**Re: MM Docket No. 99-325**

**EX PARTE COMMENTS**

I, Alan W. Jurison am personally filing these *ex parte* comments and analysis in response to the *ex parte* filing of National Public Radio (“NPR”) on November 6, 2009 of an *ex parte* meeting that was held on November 5, 2009 related to the NPR Labs Advanced IBOC Coverage and Compatibility Study (“NPR Labs Study”). In addition, I have comments related to the joint letter filed by NPR and iBiquity Digital Corporation (“iBiquity”) on November 5, 2009 (“Joint Agreement”).

Figure 23 - High Density Music at -20, -14, and -10dBc

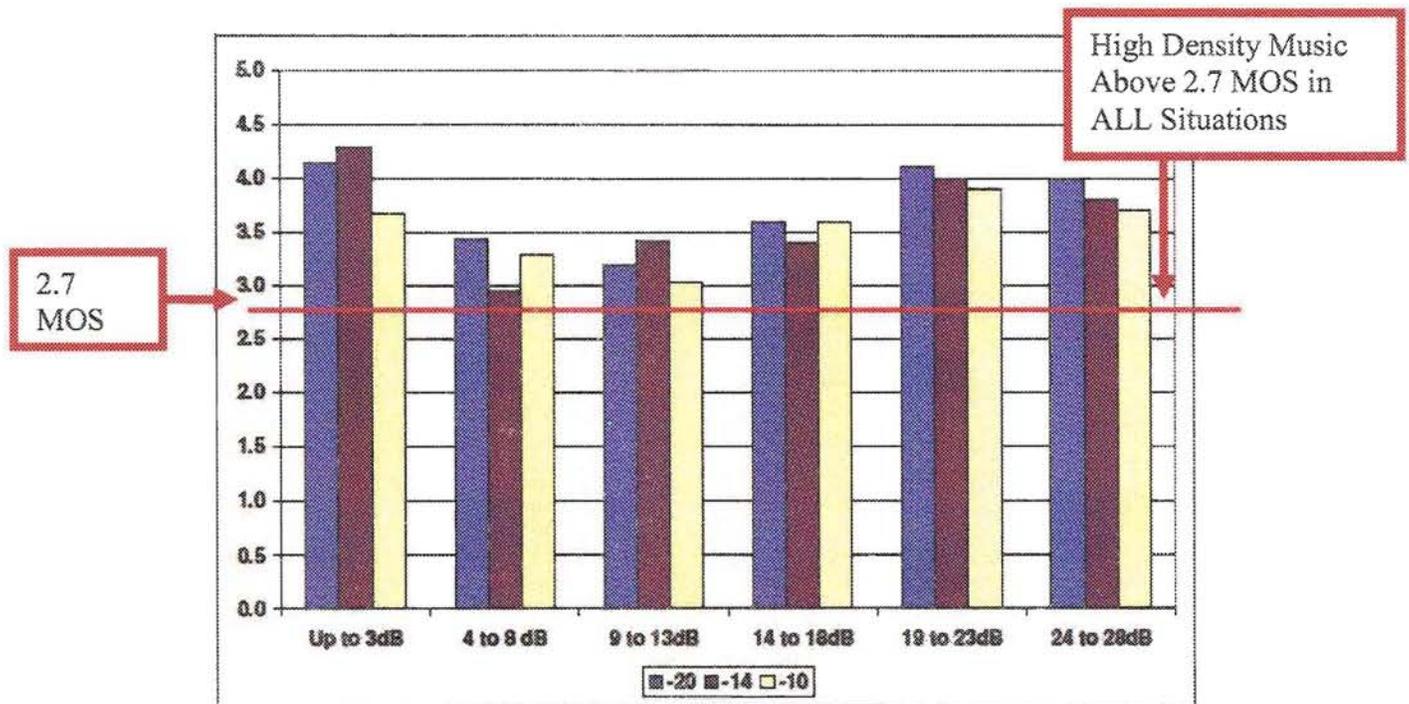
Figure 23 of the NPR Labs Report shows that there is no objectionable interference received in any situation on the graph. Each situation, whether it be -20dBc, -14dBc, or -10dBc High Density Music passes the NPR tests. The summaries of the NPR Labs Report don't mention this very important fact. These results are actually very encouraging, and the data suggests that in many situations stations should be allowed a blanket digital power increase to -10dBc. Why this isn't being brought up as a point of discussion is perplexing. In essence, buried in the NPR Labs Report, it shows that -10dBc works in High Density Music situations. This should be a key part of allowing stations to automatically go to a blanket -10dBc digital power level.

## Exhibit B: Longley-Rice Analysis of WRNI

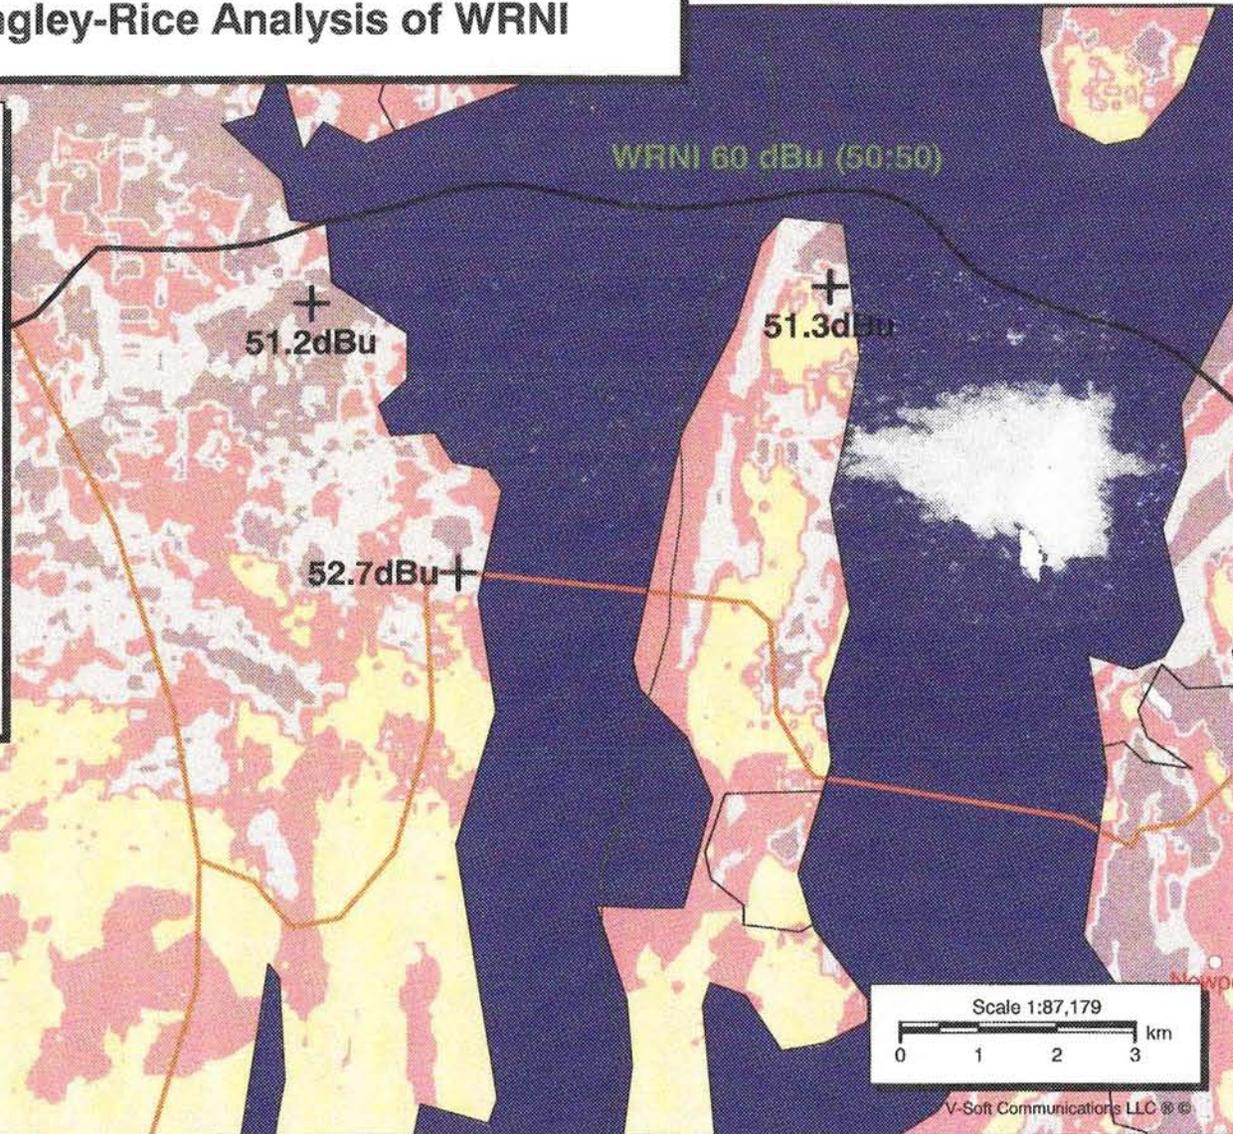
On the next page, you will see a Longley-Rice plot of WRNI compared to the D/U map data that NPR has provided in *Appendix C* of their report. You'll note three major regions where the D/U ratios become unacceptable. On the Longley-Rice plot, these regions are shaded in various forms of gray, showing received signal strengths of 40-54dBu in the general area that the D/U ratio data which NPR collected. While NPR has not provided exact location coordinates, I've outlined three points on the map proximate to the NPR route showing a predicted signal strength between 51-53dBu.
